# UNITED STATES PATENT AND TRADEMARK OFFICE

APPLICATION NO.	FILING DATE	FIRST NAMED INVENTOR	ATTORNEY DOCKET NO.	CONFIRMATION NO.
09/868,364	10/12/2001	Franz Schellhorn	P01,0212	8559
26161	7590	09/11/2007	EXAMINER	
FISH & RICHARDSON PC			RUDE, TIMOTHY L	
P.O. BOX 1022			ART UNIT	PAPER NUMBER
MINNEAPOLIS, MN 55440-1022			2871	
MAIL DATE		DELIVERY MODE		
09/11/2007		PAPER

<b>Office Action Summary</b>	<b>Application No.</b>	<b>Applicant(s)</b>	
	09/868,364	SCHELLHORN ET AL.	
	<b>Examiner</b>	<b>Art Unit</b>	
	Timothy L. Rude	2871

## DETAILED ACTION

*Fig. 6.*

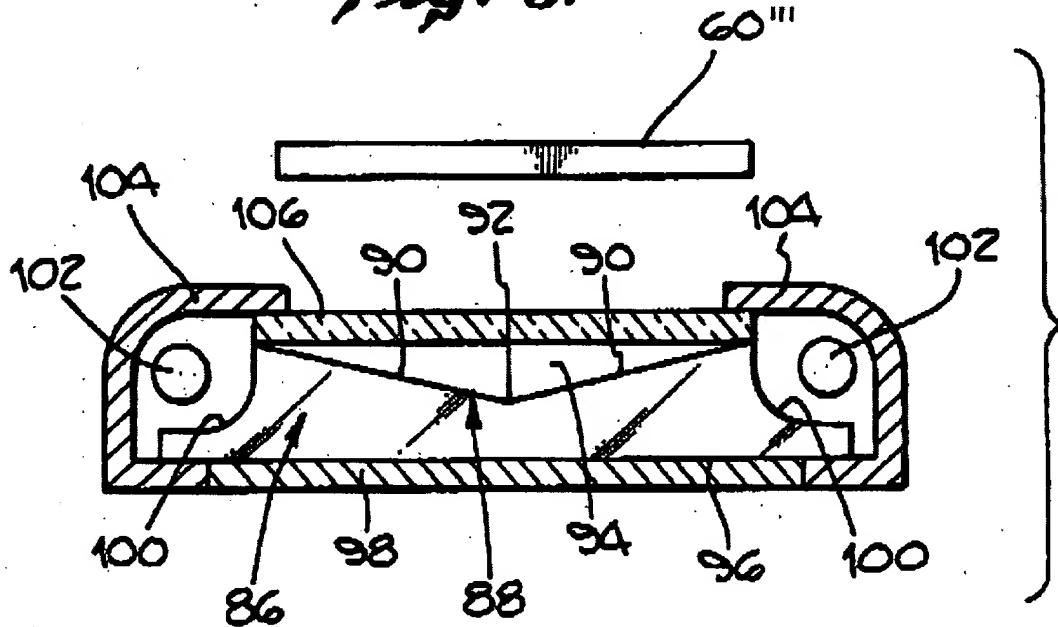
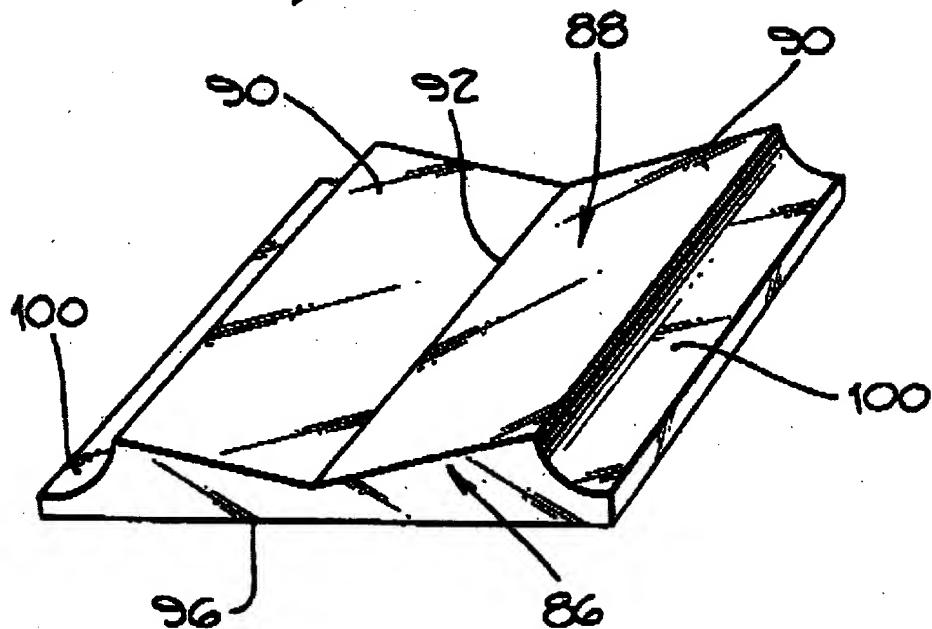
As to claim 26, Kalmanash discloses [entire patent, especially Figures 6 and 7] a light source element, comprising: a light waveguide, 86; a light exit face, 88, and at least one light entry face, 100, on the light waveguide; a reflector, 96, contacting the face that is lying opposite the light exit face, and at least some of lateral surfaces [surface facing viewer in Figure 7 and surface behind (away from viewer), as well as the lower vertical portions of the left and right surfaces] connecting the light exit face and the opposite surface being covered with reflectors, 104 on left and right, that at least one of reflect and diffusely return light;

a light source, 102, positioned in front of the light entry face, 100, that is substantially coplanar with the light source element, including the surface opposite the light exit surface wherein light enters at an oblique angle (obvious per Figure 6);

and the light entry face [concave surfaces, 100] being formed by a part of at least one of the lateral surfaces and the opposite surface not provided with a reflector and being arranged at an acute angle [concave curve has a portion that is at an acute angle – please note Applicant has not claimed planar (flat) surfaces] relative to one of principal directions of extent of the light waveguide.

Kalmanash does not explicitly disclose 1) an element wherein at least one of the light exit face and the opposite surface of the light waveguide comprise light-scattering sections and plane sections, and an area ratio of the plane sections to the light-scattering sections along the light waveguide is set such that a uniform luminance of the light source element is achieved, 2) reflectors that contact at least some of lateral surfaces connecting the light exit face and the opposite surface [newly added limitation], or 3) semiconductor light-emitting diode light sources.

FIG. 12.

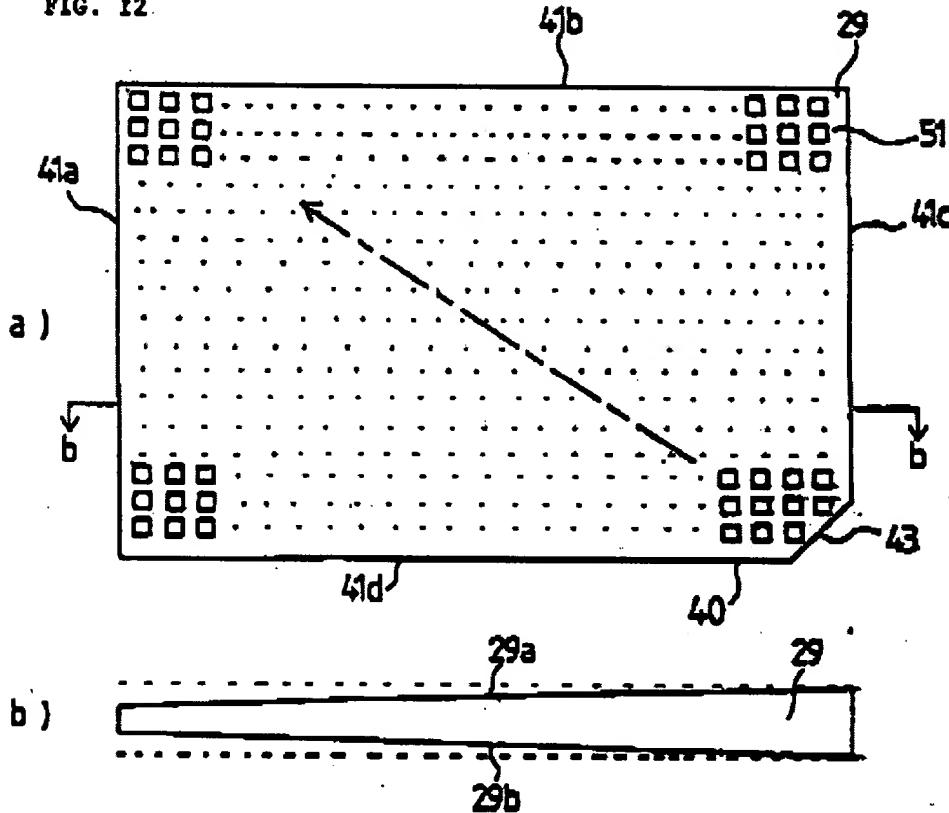
Tatsuaki teaches 1) in Figure 12 the use of at least one of the light exit face and the opposite surface of the light waveguide comprise light-scattering sections and plane sections, and an area ratio of the plane sections to the light-scattering sections along the light waveguide is set such that a uniform luminance of the light source element is

Tatsuaki is evidence that workers of ordinary skill in the art would find the reason, suggestion, or motivation to add at least one of the light exit face and the opposite surface of the light waveguide comprise light-scattering sections and plane sections, and an area ratio of the plane sections to the light-scattering sections along the light waveguide is set such that a uniform luminance of the light source element is achieved to provide improved performance directional light diffusing film.

Therefore, it would have been obvious to one having ordinary skill in the art at the time the invention was made to modify the invention of Kalmanash with the at least one of the light exit face and the opposite surface of the light waveguide comprise light-scattering sections and plane sections, and an area ratio of the plane sections to the light-scattering sections along the light waveguide is set such that a uniform luminance of the light source element is achieved of Tatsuaki to provide improved performance directional light diffusing film.

*Fig. 2*

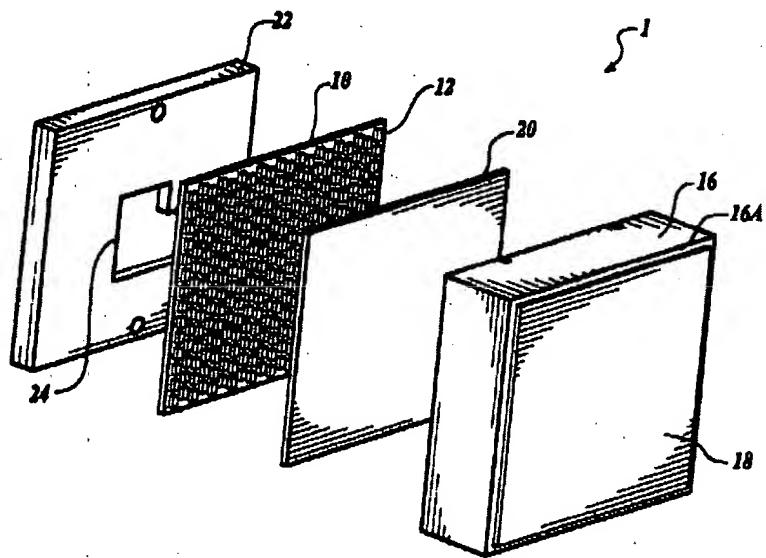
Johnson teaches 3) the advantages of using semiconductor light-emitting diode light sources, 12, [Abstract, Background, and col. 5, line 1 through col. 6, line 65] to improve reliability and efficiency (applicable to any configuration).

Johnson is evidence that workers of ordinary skill in the art would find the reason, suggestion, or motivation to add semiconductor light-emitting diode light sources [Abstract, Background, and col. 5, line 1 through col. 6, line 65] to improve reliability and efficiency.

Therefore, it would have been obvious to one having ordinary skill in the art at the time the invention was made to modify the invention of Kalmanash with semiconductor light-emitting diode light sources of Johnson [Abstract, Background, and col. 5, line 1 through col. 6, line 65] to improve reliability and efficiency.

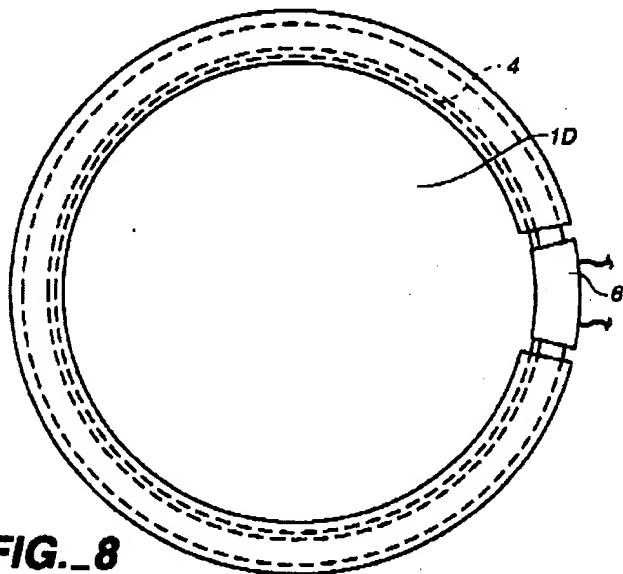
Akahane teaches that his light source element can be any of a number of shapes to accommodate different displays including a closed ring per Figure 8.

Akahane is evidence that workers of ordinary skill in the art would find the reason, suggestion, or motivation to add an element wherein the light source element forms a closed ring as an art recognized configuration suitable for illumination [MPEP 2144.07] of a display shape.

**FIG.9**

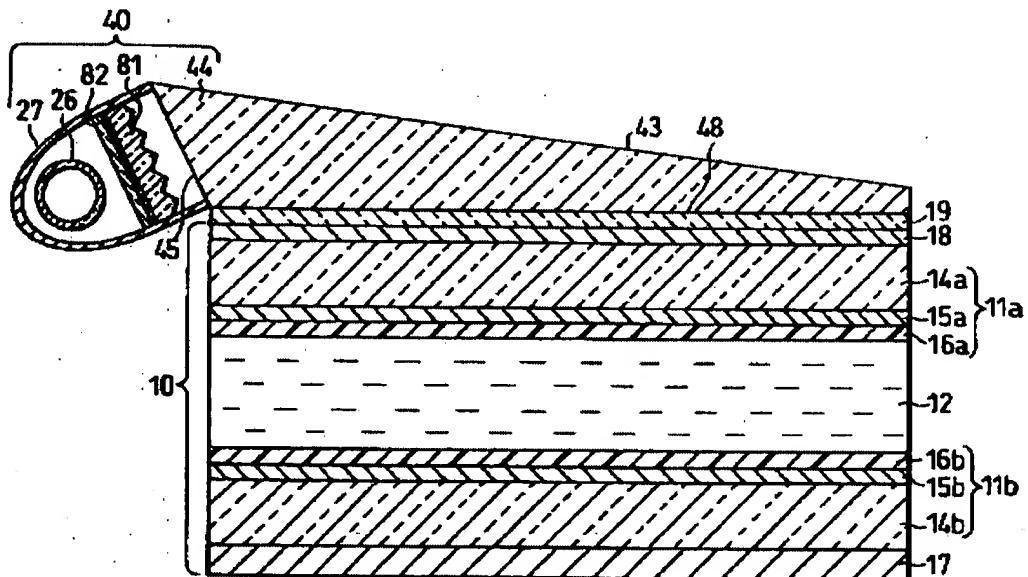
Sawayama teaches the use of a triangular projection for the illuminator in Figure 9 to achieve desired direction of the travel of light to illuminate a display [abstract].

Sawayama is evidence that workers of ordinary skill in the art would find the reason, suggestion, or motivation to add a triangular projection for the illuminator to achieve desired direction of the travel of light to illuminate a display.

Therefore, it would have been obvious to one having ordinary skill in the art at the time the invention was made to modify the invention of Kalmanash in view of Tatsuaki with the triangular projection of Sawayama for the illuminator to achieve desired direction of the travel of light to illuminate a display.

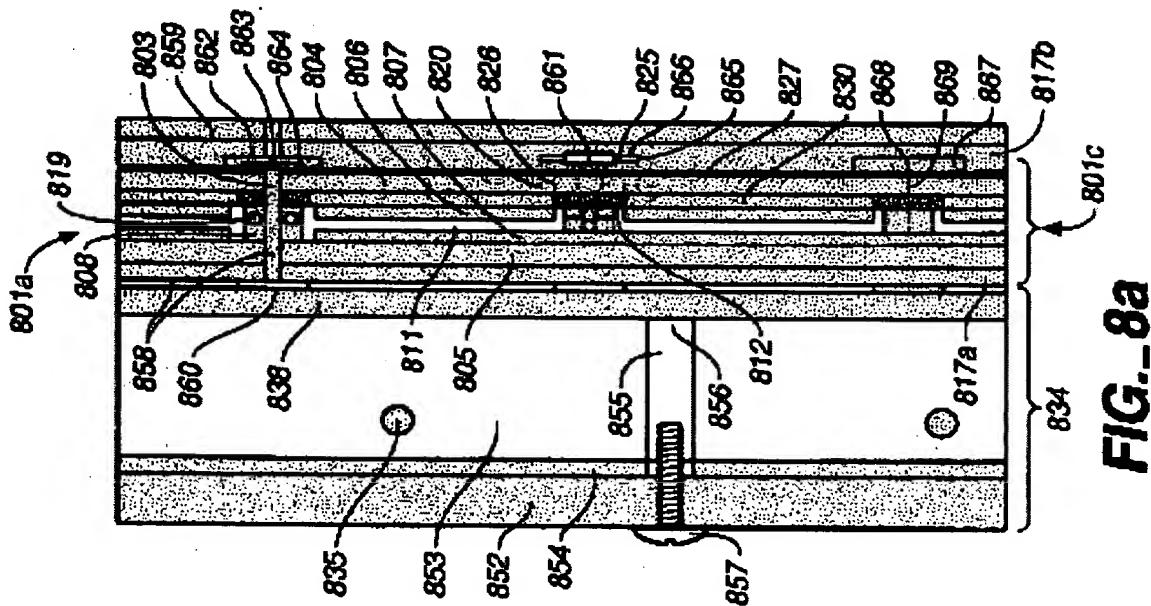
Ge teaches a display wherein the liquid crystal element is held spaced from the light exit face by spacers to provide good strength and support for a diffuser [col. 8, line 63 through col. 9, line 22].

Ge is evidence that workers of ordinary skill in the art would find the reason, suggestion, or motivation to add a display wherein the liquid crystal element is held spaced from the light exit face by spacers to provide good strength and support for a diffuser.

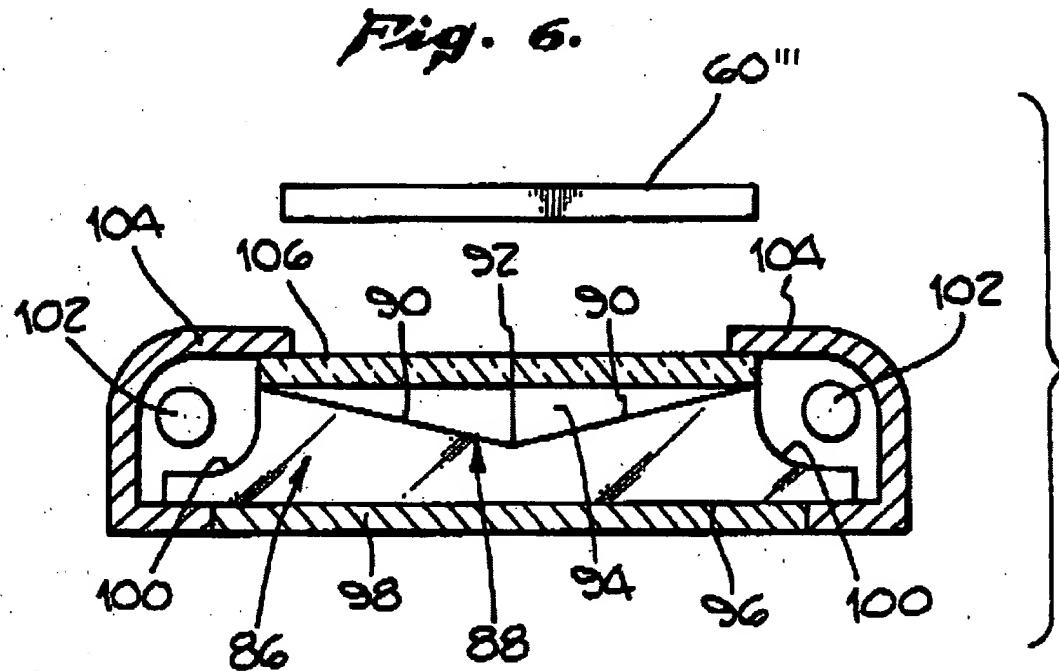
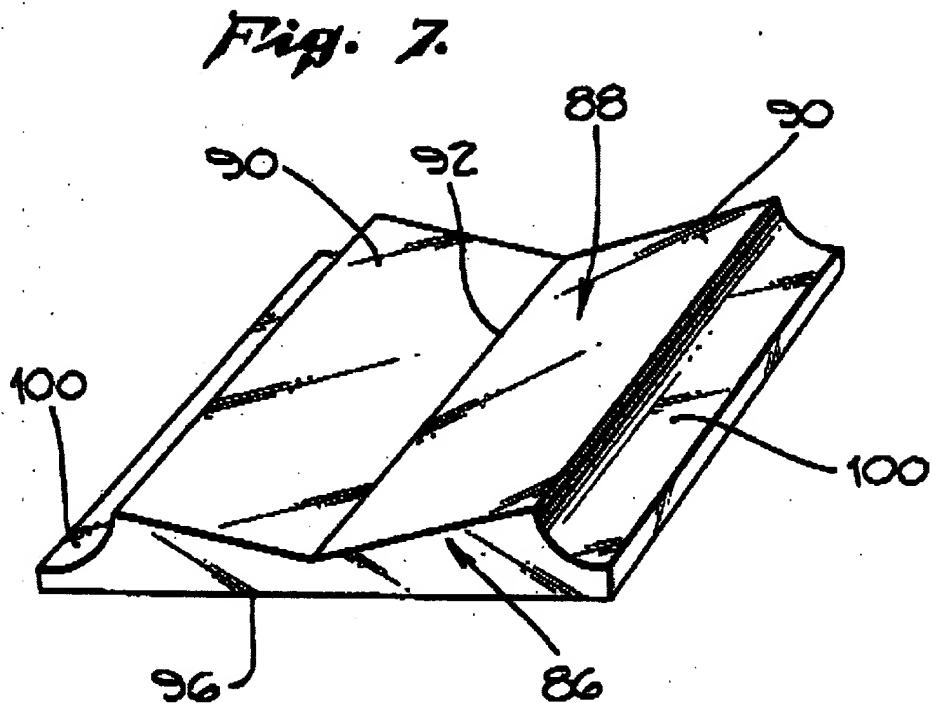
As to claims 62-66, Kalmanash discloses [entire patent, especially Figures 6 and 7] a light source element, comprising: a light waveguide, 86; a light exit face, 88, and at least one light entry face, 100, on the light waveguide; a reflector, 96, contacting the face that is lying opposite the light exit face, and at least some of lateral surfaces [surface facing viewer in Figure 7 and surface behind (away from viewer), as well as the lower vertical portions of the left and right surfaces] connecting the light exit face and

the opposite surface being covered with reflectors, 104 on left and right, that at least one of reflect and diffusely return light;

a light source, 102, positioned in front of the light entry face, 100, that is substantially coplanar with the light source element, including the surface opposite the light exit surface wherein light enters at an oblique angle (obvious per Figure 6);

and the light entry face [concave surfaces, 100] being formed by a part of at least one of the lateral surfaces and the opposite surface not provided with a reflector and being arranged at an acute angle [concave curve has a portion that is at an acute angle – please note Applicant has not claimed planar (flat) surfaces] relative to one of principal directions of extent of the light waveguide.

FIG. 12

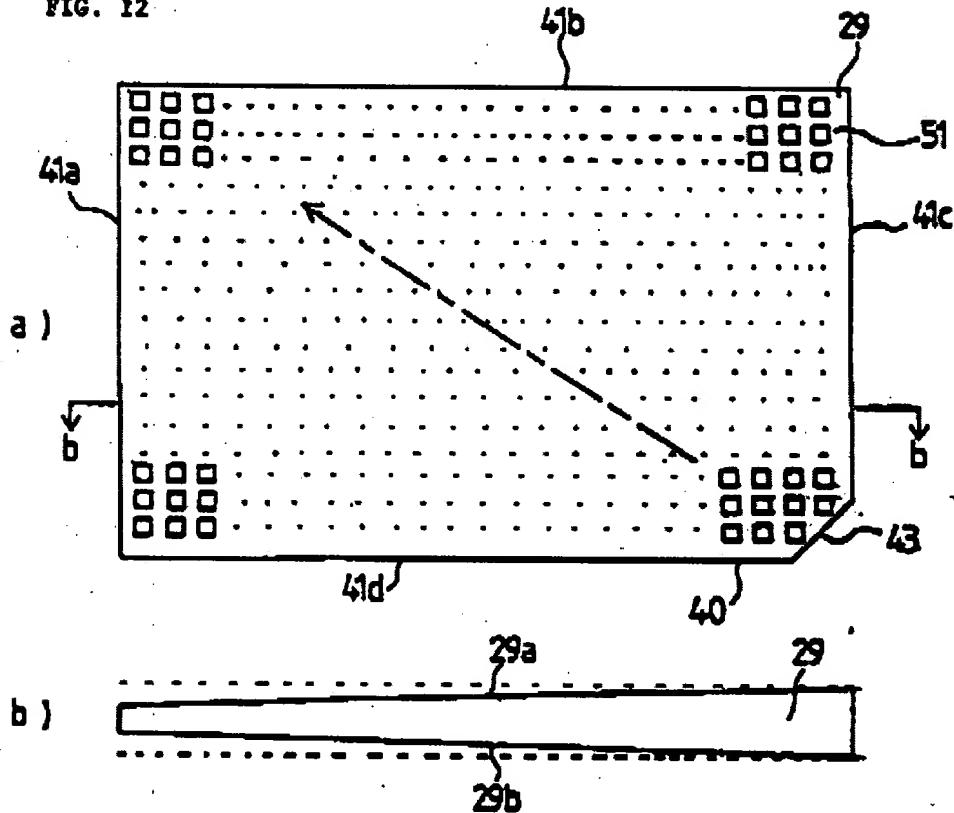
Tatsuaki teaches 1) in Figure 12 the use of at least one of the light exit face and the opposite surface of the light waveguide comprise light-scattering sections and plane sections, and an area ratio of the plane sections to the light-scattering sections along

the light waveguide is set such that a uniform luminance of the light source element is achieved to provide improved performance directional light diffusing film [Introduction (57)].

Tatsuaki is evidence that workers of ordinary skill in the art would find the reason, suggestion, or motivation to add at least one of the light exit face and the opposite surface of the light waveguide comprise light-scattering sections and plane sections, and an area ratio of the plane sections to the light-scattering sections along the light waveguide is set such that a uniform luminance of the light source element is achieved to provide improved performance directional light diffusing film.

*Fig. 2*

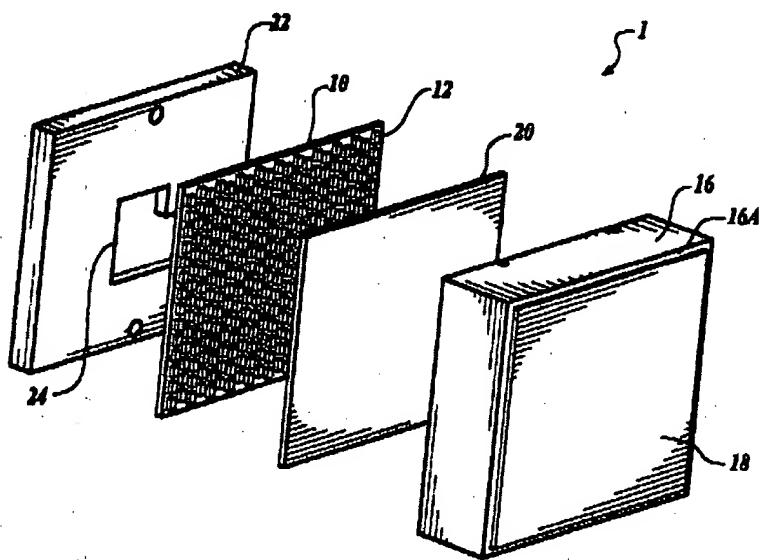
Johnson teaches 3) the advantages of using semiconductor light-emitting diode light sources, 12, and substantially parallel light exit face and surface opposite light exit face [Abstract, Background, and col. 5, line 1 through col. 6, line 65] to improve reliability, uniformity, and efficiency (applicable to any configuration).

Johnson is evidence that workers of ordinary skill in the art would find the reason, suggestion, or motivation to add semiconductor light-emitting diode light sources and substantially parallel light exit face and surface opposite light exit face [Abstract,

Therefore, it would have been obvious to one having ordinary skill in the art at the time the invention was made to modify the invention of Kalmanash with semiconductor light-emitting diode light sources and substantially parallel light exit face and surface opposite light exit face of Johnson [Abstract, Background, and col. 5, line 1 through col. 6, line 65] to improve reliability, uniformity, and efficiency.
